Date: January 11, 2016

NOTICE TO ALL BIDDERS

- 1.16 CORRECTION: Update detail 2/A3.0 with the attached 1/A3.0-SK-1
- 1.17 CORRECTION: Replace sheets A4.0, A5.0, A7.1 with the attached corresponding sheets

Project Name: CITY OF EDINBURG. FIRE STATION #5

1 PLUMBING FLOOR PLAN
P2.1 1/8" = 1'-0"

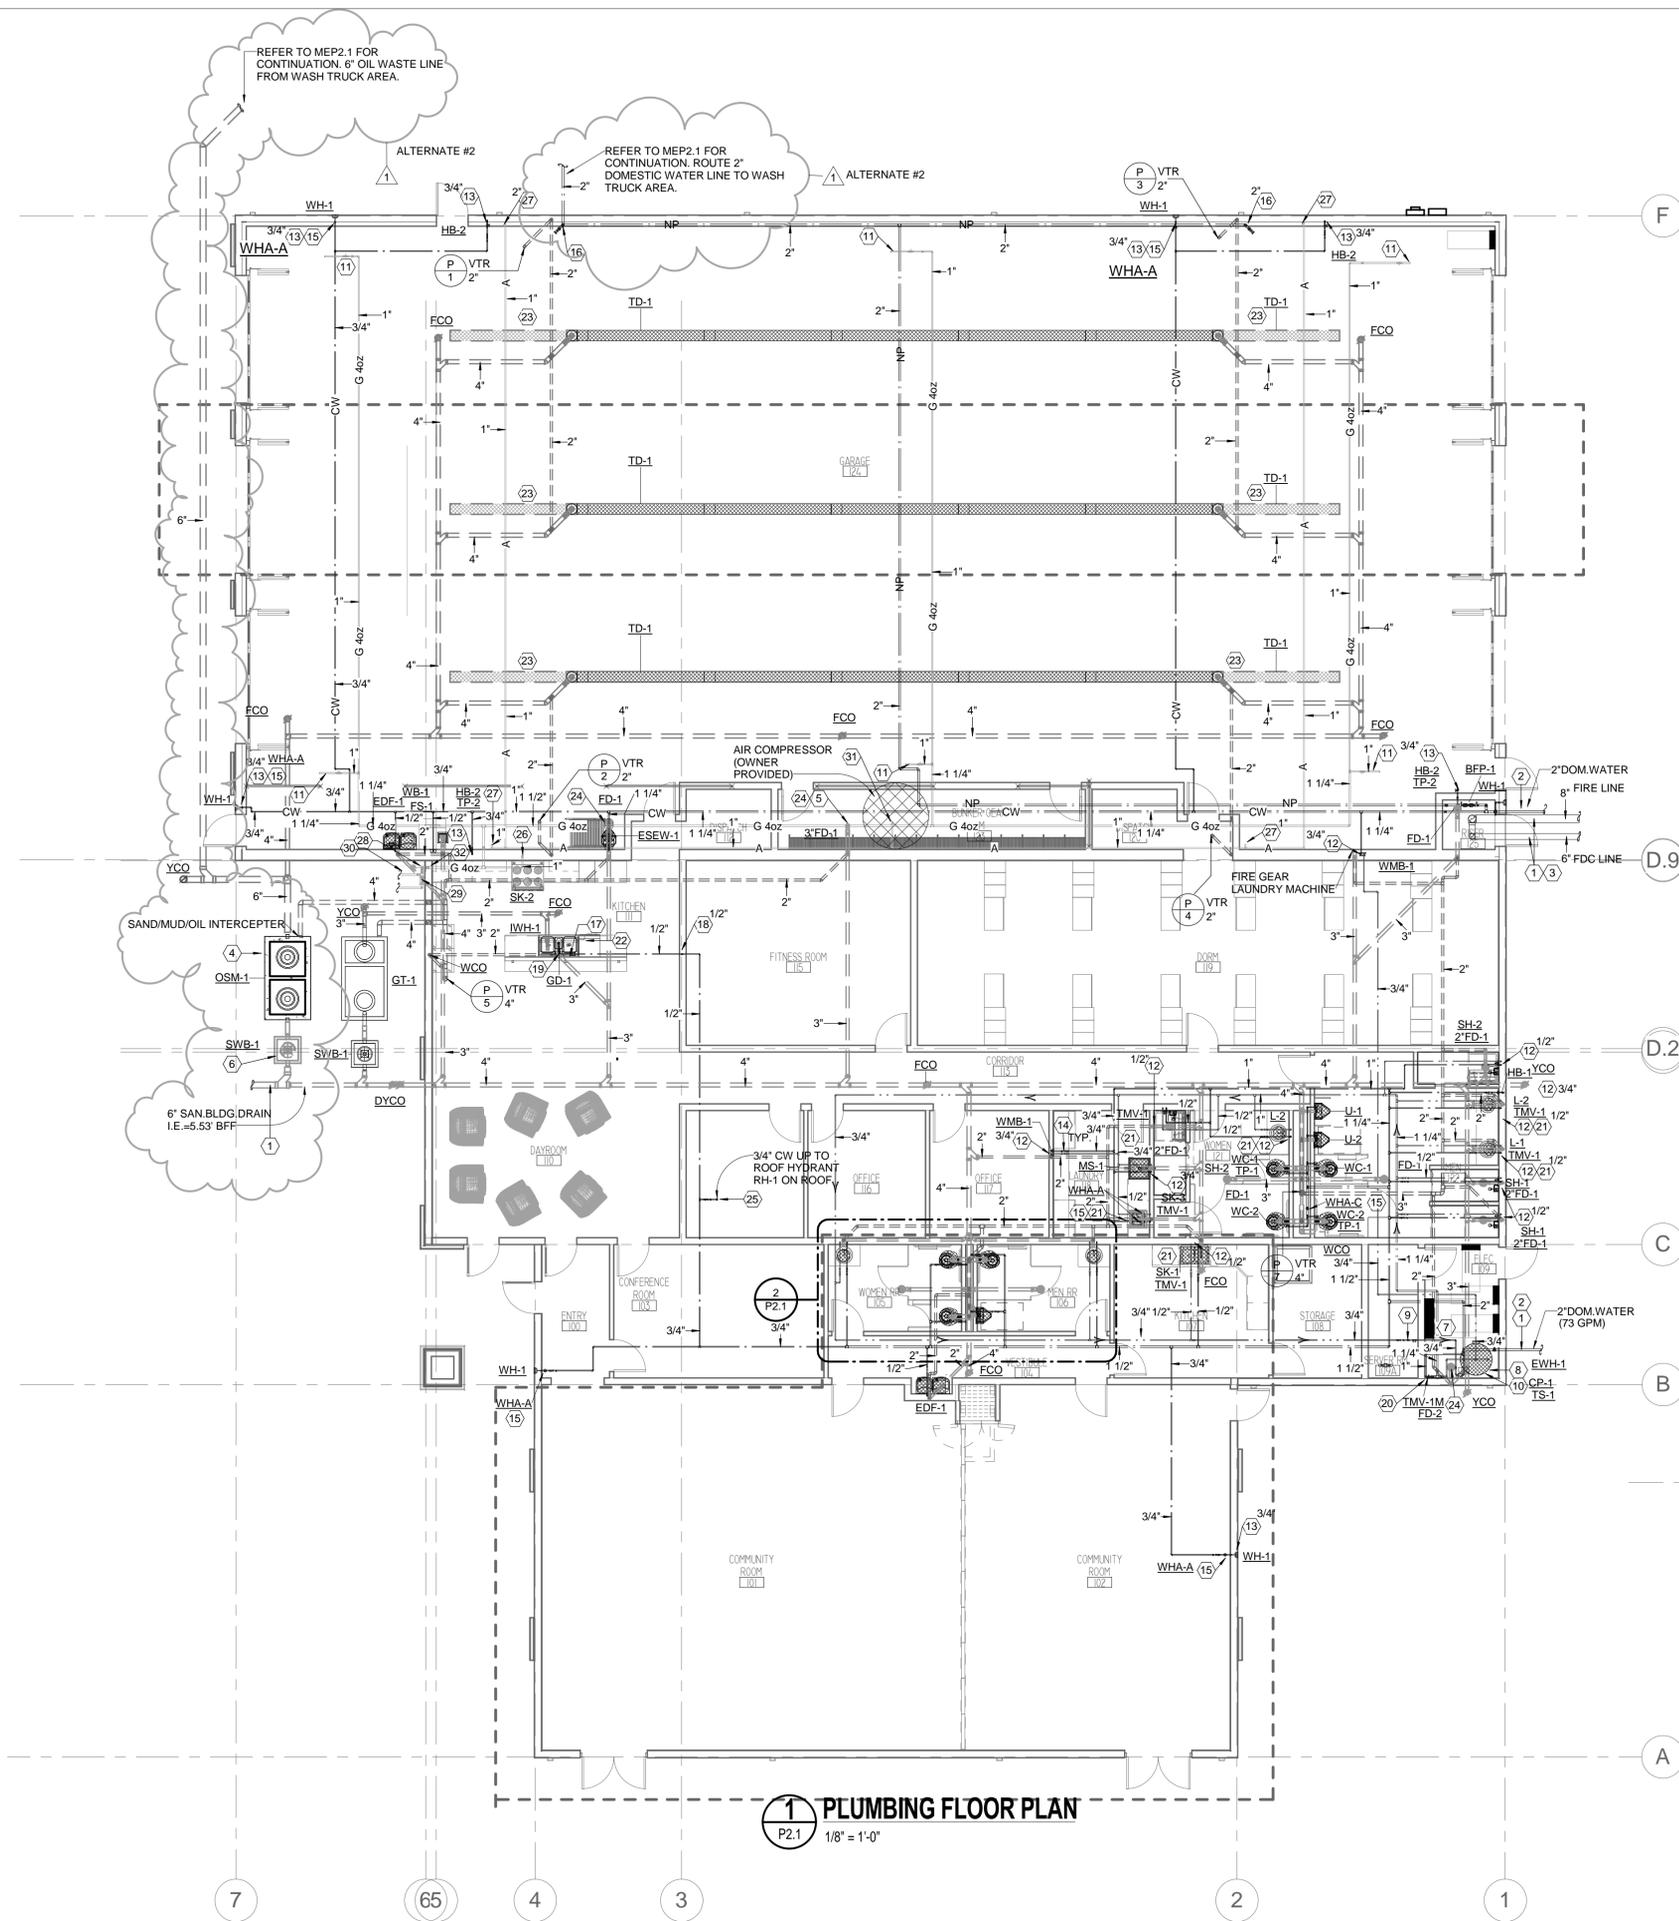
- A. Provide TP-2 for FD-1 at ESEW-1 and FD-1 at air compressor.

- B. If Alternate # 1 is not accepted, locate air compressor and 3"FD-1 in Garage Area floor.
- C. Alternate #2 – Wash Area –Provide 2" domestic water from 2" line in Garage area and route below ground and route to remote wash area. Refer to attached P2.1 and MEP2.1 for continuation.
